Acoustic Expert Report
Of
Ian MacArthur
Clarke Saunders Associates

THE PLANNING ACT 2008 PINS Ref: EN010168
Application by Lime Down Solar Park Limited for an Order granting
Development Consent for the 'Lime Down Solar Project'

SLD Wiltshire Limited

Plate 8: LT8 Measurement Time History (Solar PV Sites)

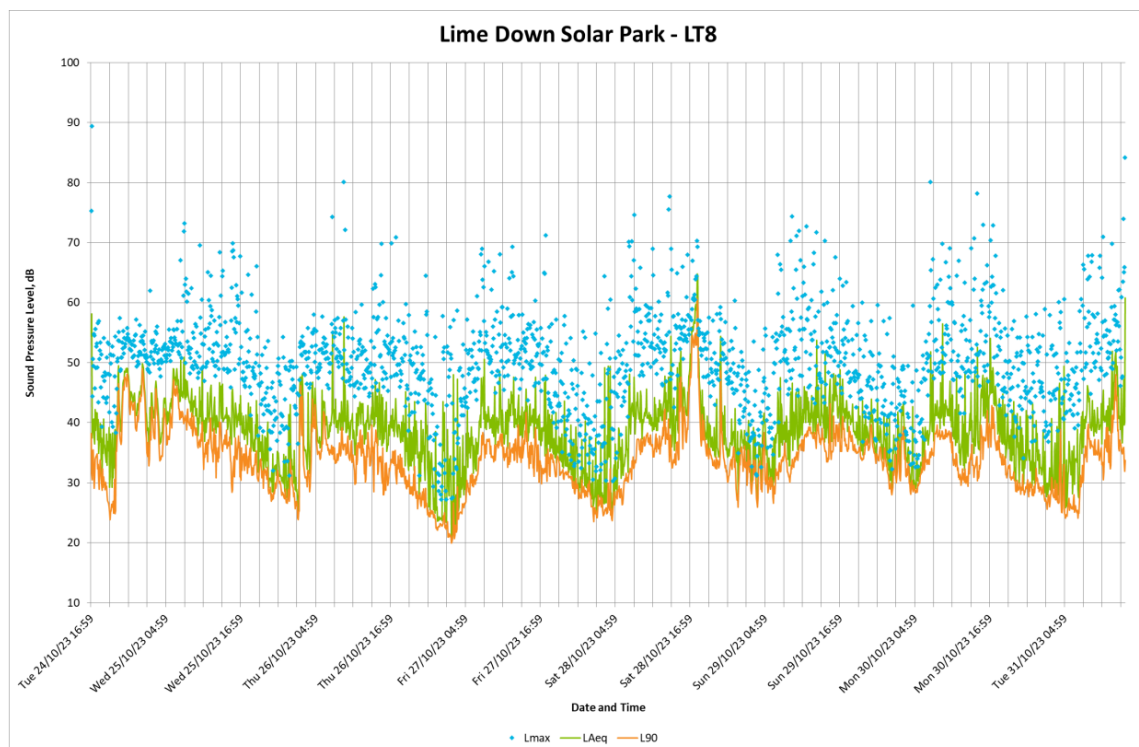
- 5.6 Table 14-17 of the ES summarises ranges of what appears to be the daily averaged measured background levels. The Baseline Noise Survey Plate 8 clearly shows that night-time levels at location LT8 can fall below 30dBL_{A90} during the day and down to 20dBL_{A90} at night.

- 5.7 The statistical distribution of background levels at location LT8 is presented as a histogram in the Baseline Noise Survey Plate 36, as shown below. This clearly shows the actual ranges of background levels measured during the survey. Highlighted in yellow are the Applicant's selected single-figure daytime and night-time background values for subsequent use in the assessment. The rationale or justification for selection of these values is not explained within the ES, and it is not defined whether they are mean, median or other value. Inspection suggests that quite simply, the mean (average) value from the dataset has been used. The Applicant's Response to Relevant Representations (Part 1) at [PDA-009] SLD-096 suggest they have simply used '*professional judgement*' which '*are close to but not always the modal levels*'; regardless of the approach adopted, these comments still apply.

Plate 36: LT8 LA90 Histograms (Solar PV Sites)

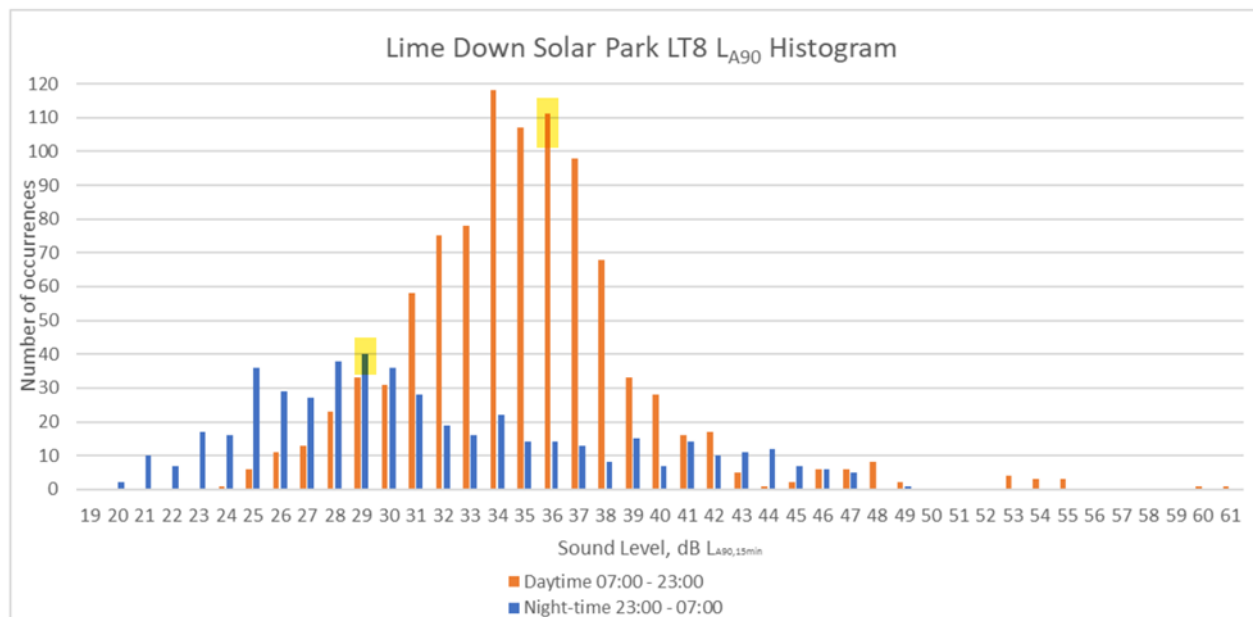
- 5.9 It is clear that background levels during the survey period were below the selected daytime value for more than 50% of the time, falling up to 11dB lower. It is noted that the use of the absolute lowest levels is not always appropriate, although it would represent a 'precautionary' approach which may be appropriate in varying circumstances. A reasonably robust assessment approach, given the limited survey duration, would be to select a value representative of the *lower range* of background levels measured during that limited period – in this instance, a value in the range 23-25dB_{LA90} at night, and around 30dB_{LA90} during the daytime could be judged to provide a more reasonable and robust representation of typical background levels for the assessment at this location based on this limited sample dataset.

- 5.16 I disagree, in that the Applicant has determined 36dB_{LA90} as single figure daytime background level from the statistical distribution shown above, the selection of which clearly sits above a median or modal value of the normal distribution and has clearly been skewed by the infrequent higher values. In their response, the Applicant does not explain what their professional judgement basis was for selection of this value, or how this is appropriate to represent the ‘typical’ background noise level at the receptor at all times. It does not have regard to what BS4142 and the guidance direct attention to in identifying likely significance of noise effects and reflecting the range of background noise outcomes.

Plate 12: LT12 Measurement Time History (Solar PV Sites)

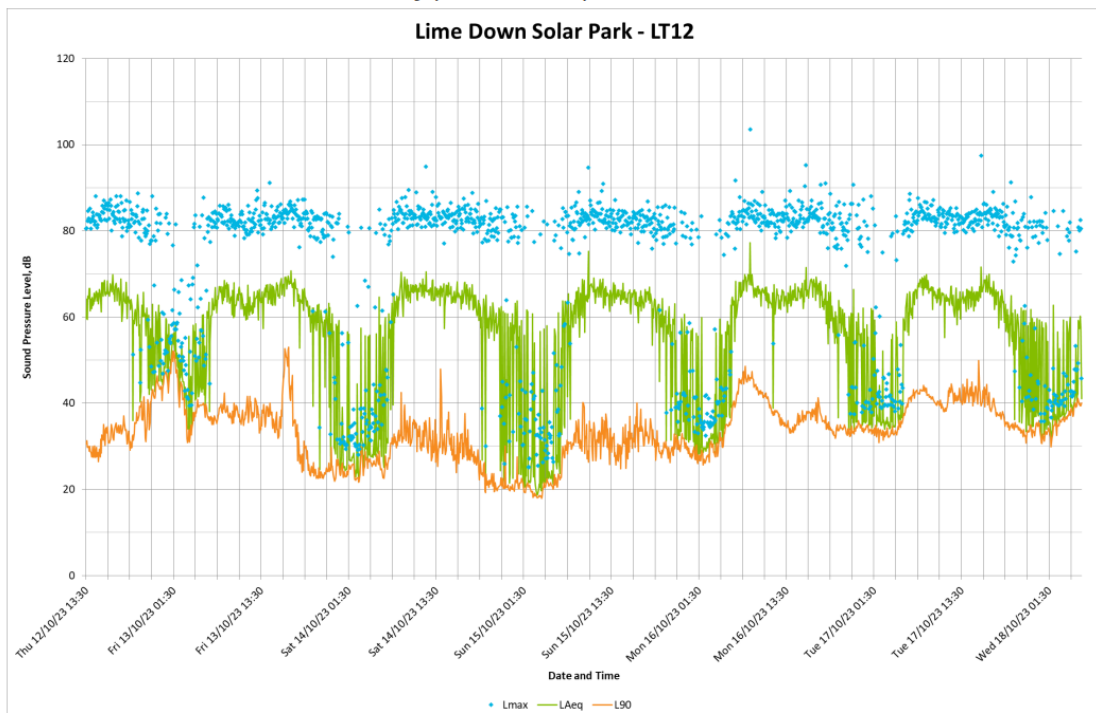
- 5.24 The weather during this survey was not reported or seemingly monitored by the Applicant at or near the monitoring location. From sourced weather data nearby, there is evidence that the area was influenced by raised winds over 5m/s and periods of rainfall on the 12th and 13th of October. The 14th and 15th may have had periods of rain, but low winds. The 16th to 18th were likely influenced by wind speeds over 5m/s.

- 5.26 During this calmer period between the 14th and 15th, it can be seen that daytime background levels typically fluctuate around 30dB_{LA90}, but can fall to the low 20s during daytime periods. At night, the background is shown to be around 20dB_{LA90}.

Plate 40: LT12 LA90 Histograms (Solar PV Sites)

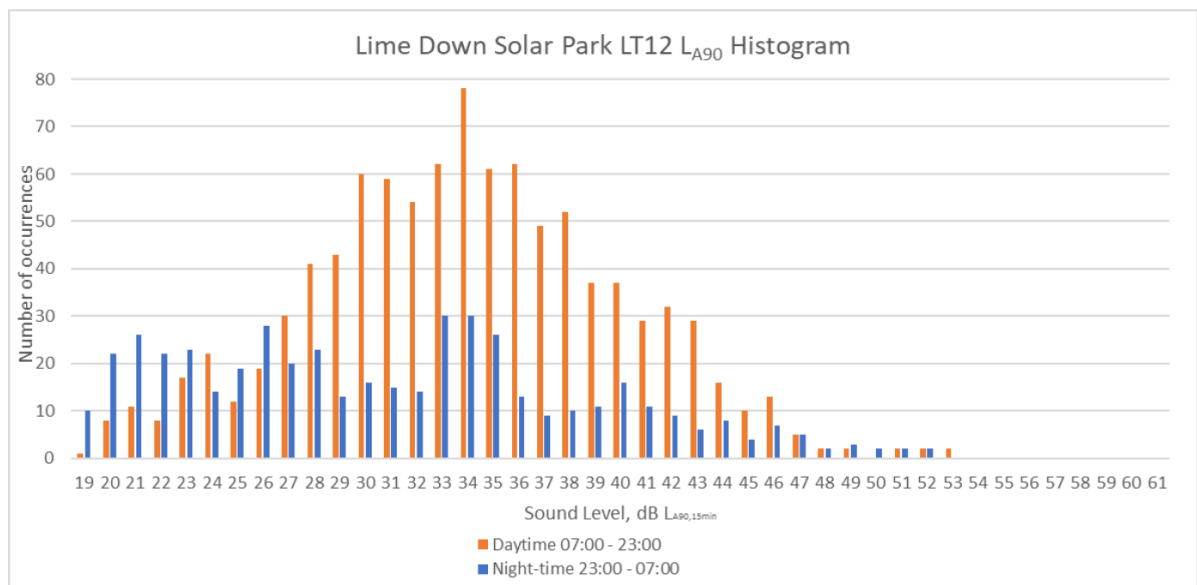
- 5.28 The Applicant’s statistical analysis of the background levels for the monitoring period is shown above. In the background summary table, they have selected a ‘typical’ background level of 34dB_{LA90} during the daytime and 30dB_{LA90} during the night for the location. This appears to be a simple selection of the mean values and there is no justification for selection of these values being representative of a ‘typical’ scenario, as background levels are shown to be lower for at least 50% of the limited duration of the survey.
- 5.29 They do not represent typical background condition that could be expected at Bradfield Manor on a typical day with relatively low winds and no precipitation. During periods of calmer weather, it is clear that the background levels at this location vary around 30dB_{LA90} during the daytime, and around 20dB_{LA90} at night. The resultant effect

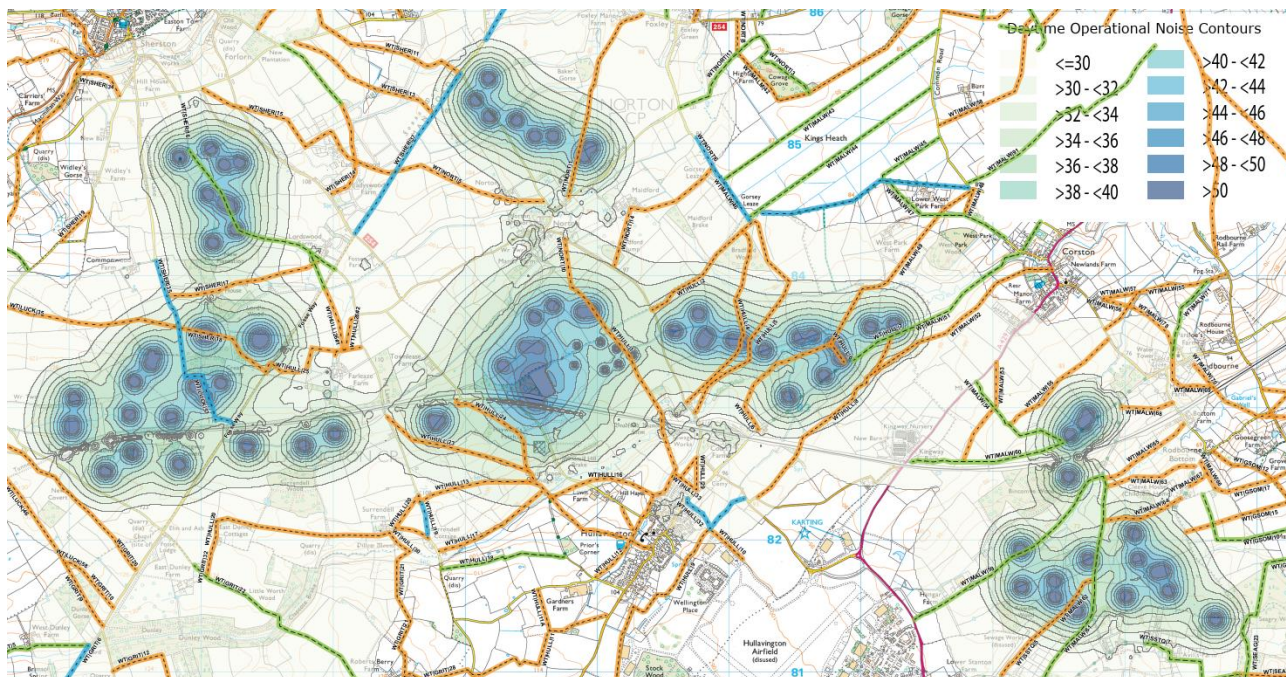
- 5.30 Bradfield Manor would currently experience very low background noise levels during the daytime and night-time periods, characterised by the absence of industrial noise sources.

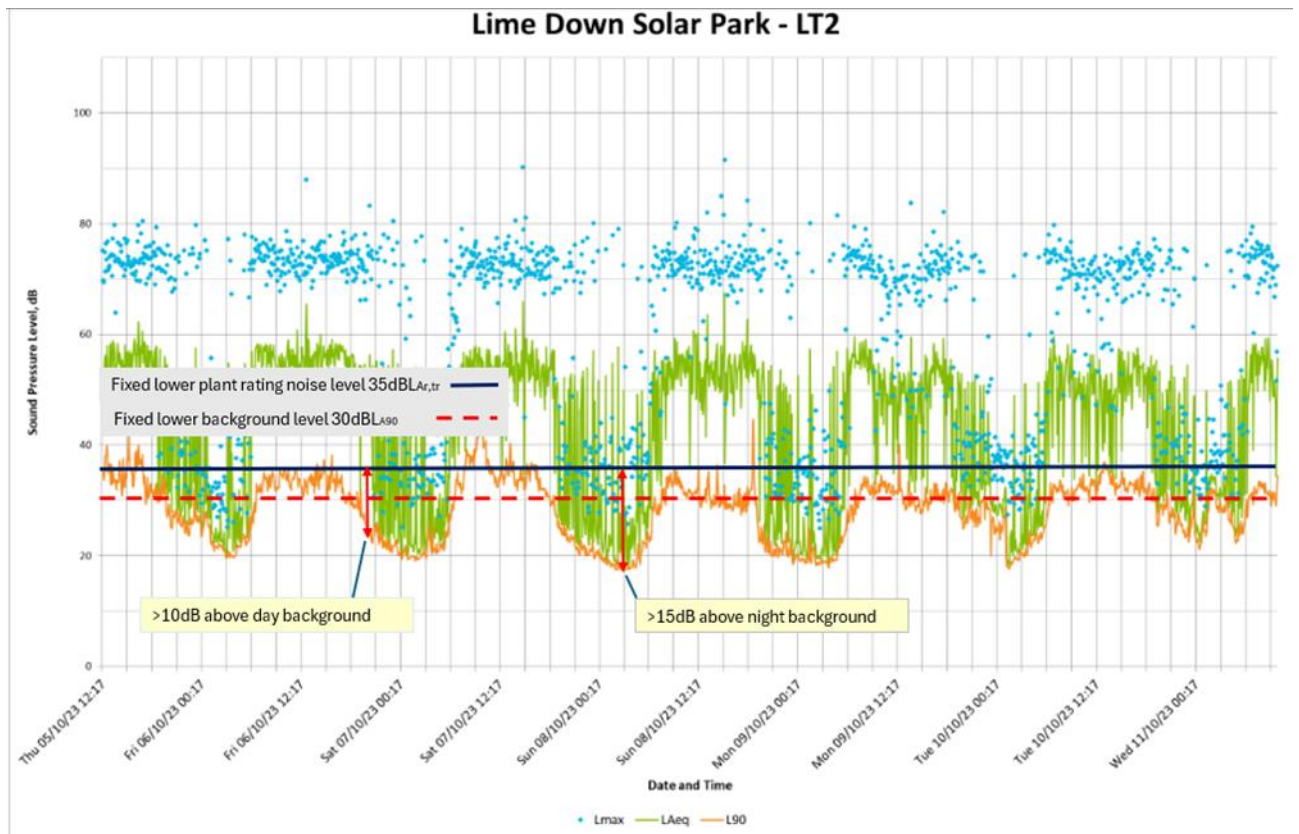
- 6.24 The figure below illustrates how the adopted fixed plant noise assessment threshold would sit against the background noise measurements from monitoring location LT2.

6.25 As noise from the development will be generally continuous, the background noise levels (orange line), ambient and maximum would therefore be permanently raised toward the dark blue line.
